SAFETY RECALL BULLETIN

SUBJECT:		No:	SR-09-003
SEAT AIR BAG BRACKET ANCHOR — SAFETY RECALL CAMPAIGN		DATE:	September, 2009
		MODEL:	See below
CIRCULATE TO:	<input type="checkbox"/> GENERAL MANAGER	<input checked="" type="checkbox"/> PARTS MANAGER	<input checked="" type="checkbox"/> TECHNICIAN
<input checked="" type="checkbox"/> SERVICE ADVISOR	<input checked="" type="checkbox"/> SERVICE MANAGER	<input checked="" type="checkbox"/> WARRANTY PROCESSOR	<input type="checkbox"/> SALES MANAGER

Header Section: Certain 2010 Endeavor seat side air bag anchor bracket inspection

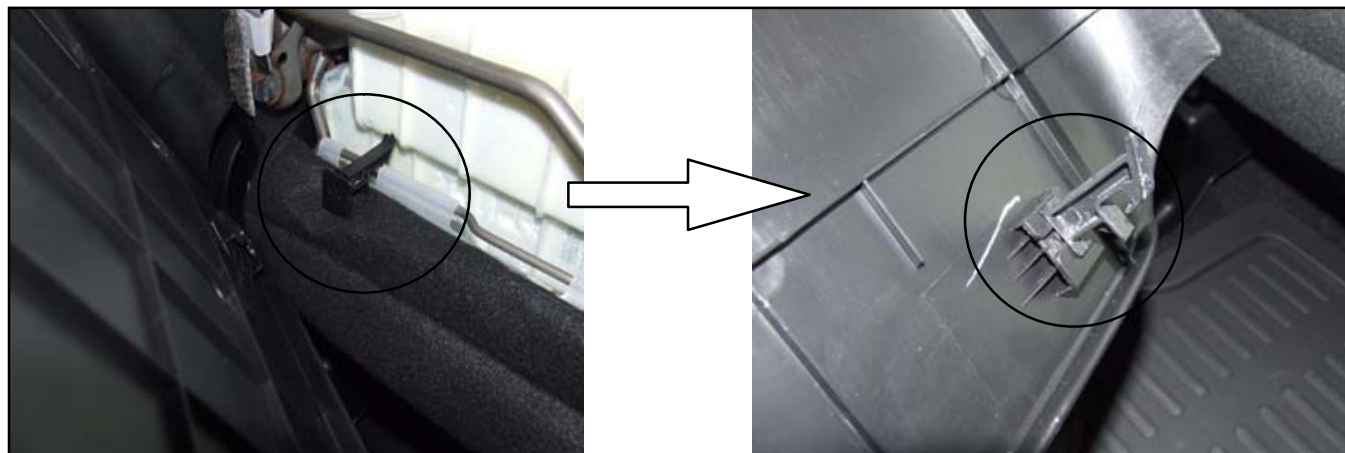
- Remove the seatback panel as follows:

- Insert a trim stick or screwdriver between the seatback panel and lower edge of the seat, and push toward the center of the seat to unseat the two lower clips securing the panel on each side.
- Pull the lower edge of the panel out and slide the panel downward to remove it. If necessary, strike the top center of the panel to release the upper clips.

3. Inspect the side airbag anchor welds as follows:

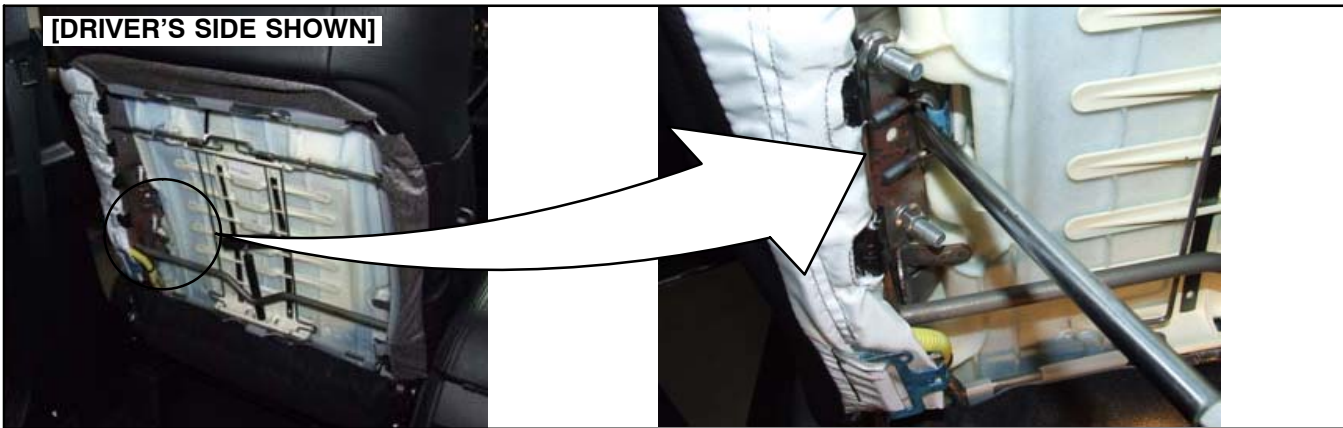
- a. Use a large flat-tip screwdriver 12" in length. Insert the screwdriver between the seatback frame and the anchor hook.

- b. Grasping the screwdriver firmly, pull it inboard (toward the center of the vehicle) with 5–6 kg (11–13 ft/lb) of force just until the seat frame flexes slightly, **so that the handle end of the screwdriver moves approximately 10mm.**

USE ONLY 5–6 KG (11–13 FT/LB) OF FORCE. DO NOT PULL WITH EXCESSIVE FORCE!

- c. **If the bracket welds crack or break, replace the seatback.** Follow the seatback replacement procedures in Group 52B of the 2010 Endeavor service manual. Please notify Tech Line if seat back replacement is necessary. Retain the packaging of the new seatback to return the old seatback.
4. **If the bracket weld does NOT crack or break,** reinstall the seatback panel as follows:
- a. Confirm the two lower clips are installed on the seatback.
- b. With the bottom of the seatback panel angled slightly rearward, insert the upper portion of the panel into the seatback. Be sure that the upper clips are engaged.
- c. Place your hands on the lower portion of the panel and push until the lower seatback clips engage the seat frame.
